STAFF RECOMMENDATION 1823 5th Avenue North July 17, 2019

Application: New Construction—Addition and Outbuildings; Partial Demolition

District: Salemtown Neighborhood Conservation Zoning Overlay

Figure 2: Existing right-side façade.

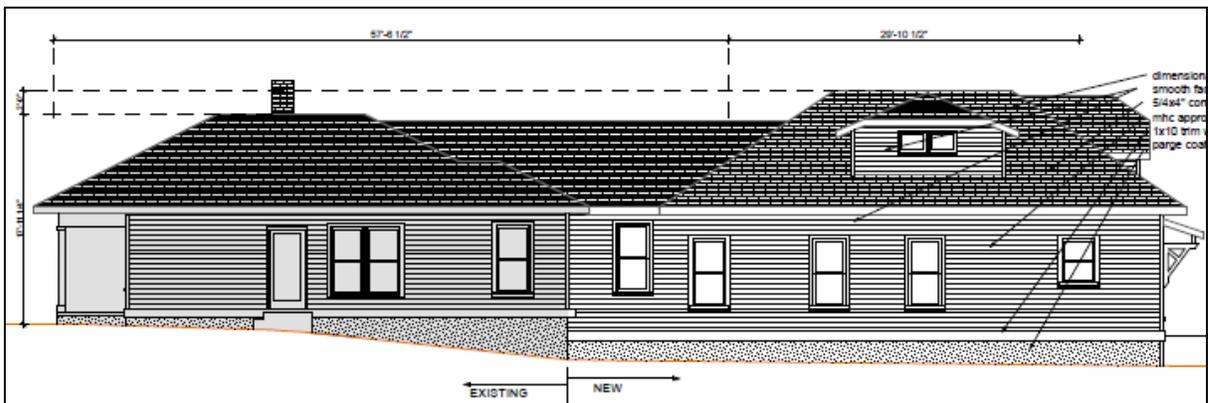
Partial Demolition: The applicant proposes to elongate an existing window opening on the right-side façade near the rear of the house and to add a door near the midpoint (Figures 2 and 3). Staff finds that both proposed changes can be appropriate since they are located on a side façade at or beyond the midpoint. In addition, the location of the window opening is not changing.

For these reasons, staff finds that the partial demolition is appropriate meets Section V.B.2 for appropriate demolition and does not meet Section V.B.1 for inappropriate demolition.

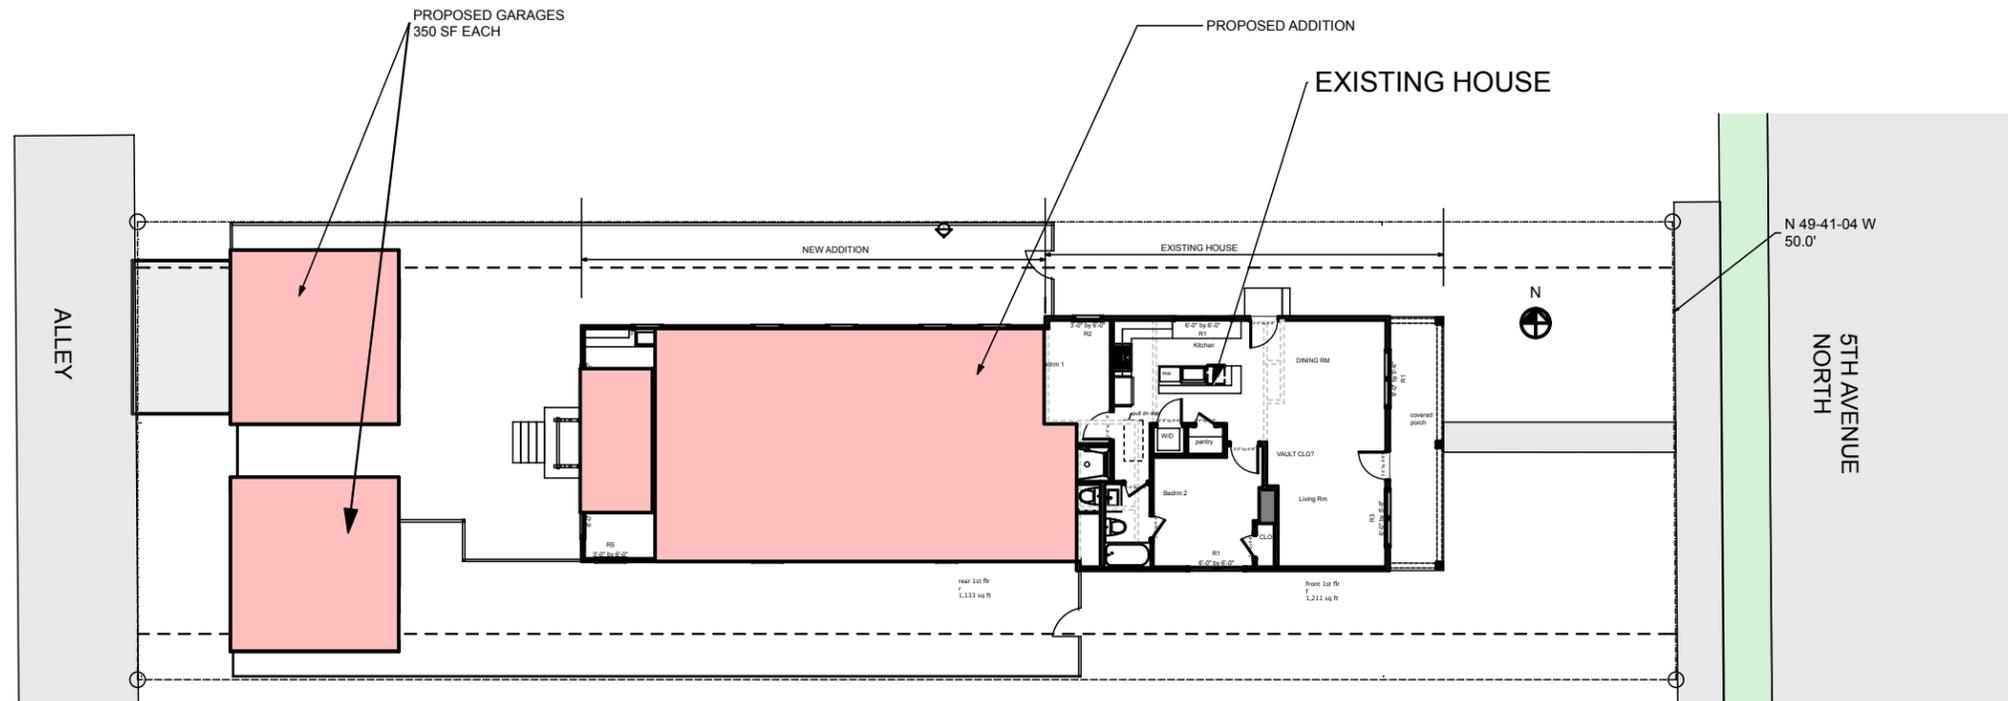
The roof and eave heights of the proposed garage meet the requirements of the design guidelines. The proposed square footage of each outbuilding is three hundred fifty square feet (350 sq. ft.) for a total outbuilding footprint of seven hundred square feet (700 sq. ft.). The lot is approximately eight thousand, four hundred, forty-six square feet (8,446 sq. ft.), and the guidelines allow outbuildings to be up to seven hundred fifty square feet (750 sq. ft.) on lots less than ten thousand square feet (10,000 sq. ft.). Staff finds the height and scale of the proposed outbuilding meets Section III.H.1 of the design guidelines.

Design Standards: The outbuildings will have a simple, utilitarian design, which is appropriate for outbuildings. The materials, proportions, and overall character of the outbuilding will not contrast greatly from the historic house. Its roof pitch and materials will match those of the historic house. The window proportions and locations are compatible with those of outbuildings historically. Staff finds the design of the proposed outbuilding to meet Section III.H.2 of the design guidelines

With the that condition that the final window, door, garage door, trim, and roof color selections are approved by MHZC Staff prior to purchase and installation, the project will meet Section III.H.4 and 5 of the design guidelines for Materials.

DATE: 7/8/19
REVISION
PROJECT NO: 19-051
COPYRIGHT 7/8/19 QUIRK DESIGNS
1ST FLR PLAN

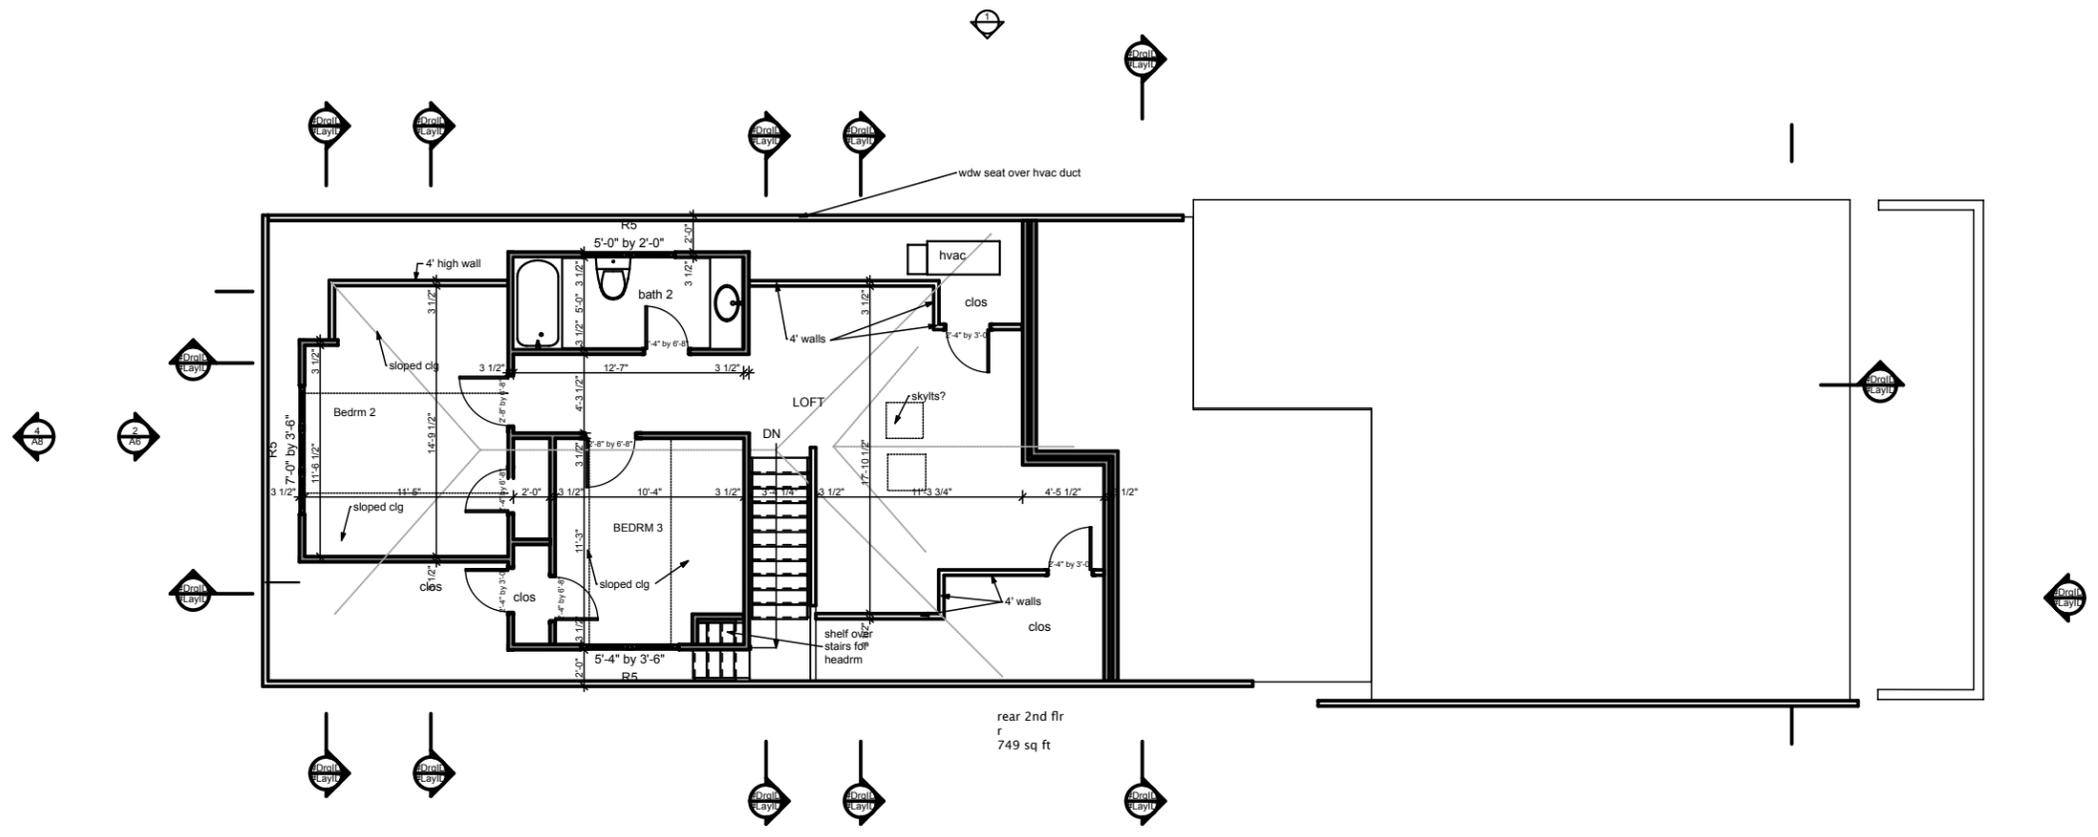
The historic house has a depth of approximately forty-three feet, seven inches (43'-7"), including the front porch. The proposed addition is deeper than that of the historic house, with a depth of fifty feet, nine inches (50'-9"). The footprint of the addition is also larger than that of the historic house. The existing house has a footprint of approximately one thousand, one hundred, and ninety-three square feet (1,193 sq. ft.). This includes the front porch. The addition, including the rear covered stoop, has a footprint of approximately one thousand, four hundred, and eight square feet (1,408 sq. ft.). The addition more than doubles the footprint and depth of the historic house, which is not something that has been approved recently, except in cases of exceptionally small historic houses.

Staff finds that the larger footprint is not appropriate in this case since the house's footprint is not exceptionally small. In addition, the addition is proposed to be taller than the historic house and having a footprint that is larger than that of the historic house makes the overall height and scale of the addition inappropriate. Staff recommends that the addition, including all covered porches, have a footprint no larger than one thousand, one hundred, and ninety-three square feet (1,193 sq. ft.), which is the footprint of the historic house.

1. The footprint of the addition, including all covered porches, covered decks, and two-story decks, be no larger than one thousand, four hundred, and twelve square feet (1,412 sq. ft.), which is the footprint of the historic house;
2. Staff approve the final details, dimensions and materials of windows, doors, trim, roof color, and garage doors prior to purchase and installation;
3. The HVAC be located behind the house or on either side, beyond the mid-point of the house; and
4. Utility meters be located on the sides or rear of the building. Alternative mechanical and utility locations must be approved prior to an administrative sign-off on the building permit(s).
